Additional Information
SD22A/0347 28/6/23

RE: REPSONSE TO REQUEST FOR ADDITIONAL INFORMATION IN RESPECT OF A PROPOSED RESIDENTIAL DEVELOPMENT OF 42 UNITS AND ASSOCIATED INFRASTRUCTURE AND WORKS AT A 2.9 HECTARE SITE TO THE EAST OF STONEY HILL ROAD, RATHCOOLE, INCLUDING PART OF STONEY HILL ROAD AND THE ROADWAY AT THE EASTERN SIDE OF RATHCOOLE PARK

REG. REF: SD22A/0347

Figure 1: Extract from Wilson Hill Architects Dwg. No. P350

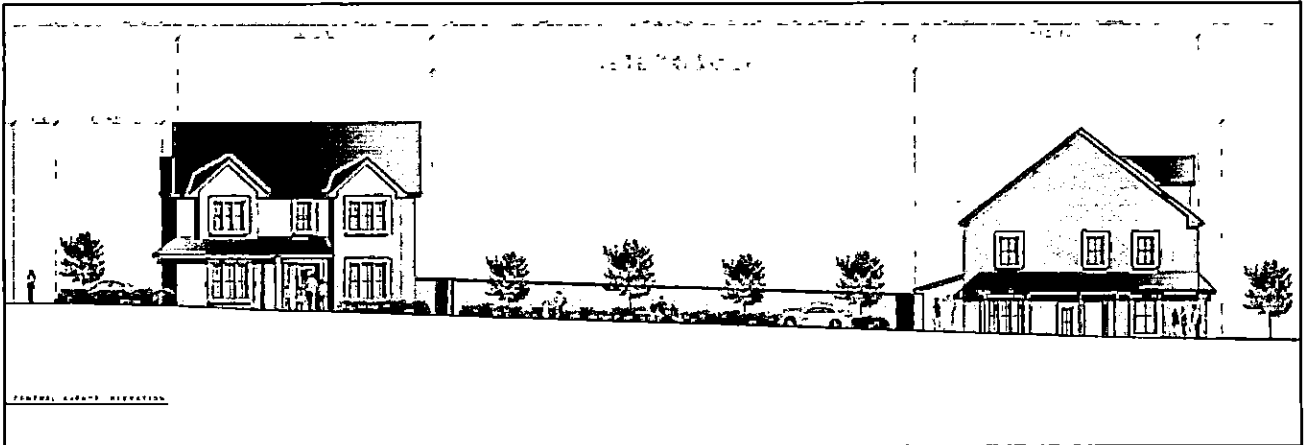
“The applicant is requested to reconsider the following aspects of the scheme layout:

- (a) *The applicant should consider alterations to the east and west ends of each block to provide wraparound units and west/east-facing mid block units, minimising instances where gardens side/back onto the street, and maximising active frontage onto streets and open spaces.*
- (b) *The submitted site section shows that the garden walls would not be tall enough to ensure privacy at some points along the central street.*
- (c) *Additional site sections or landscape details should specify the proposed boundary treatment between the rear gardens, specifically whether larger retaining walls are being utilised to step down the hill”.*

5.6 In relation to item (a), the proposed scheme includes dual frontage wrap-around units (units L2, F3, F4), to the east and west ends of block as illustrated on the proposed site layout plan 2227-(P)107A – Proposed Site Layout Plan. The photomontage included on the 'Proposed Central Avenue Details' drawing (P)350, and extract included below, illustrates the wrap around units along the central street where they maximise the active frontage.

- 5.7 In relation to item (b), the submitted site section (Wilson Hill Architects Dwg. No. (P)312A) has been amended to show the garden walls are all to be 1.8 metres tall to ensure privacy at some points along the central street.
- 5.8 In relation to Item (c), please refer to accompanying landscape details specifying boundary wall treatment between the rear gardens.
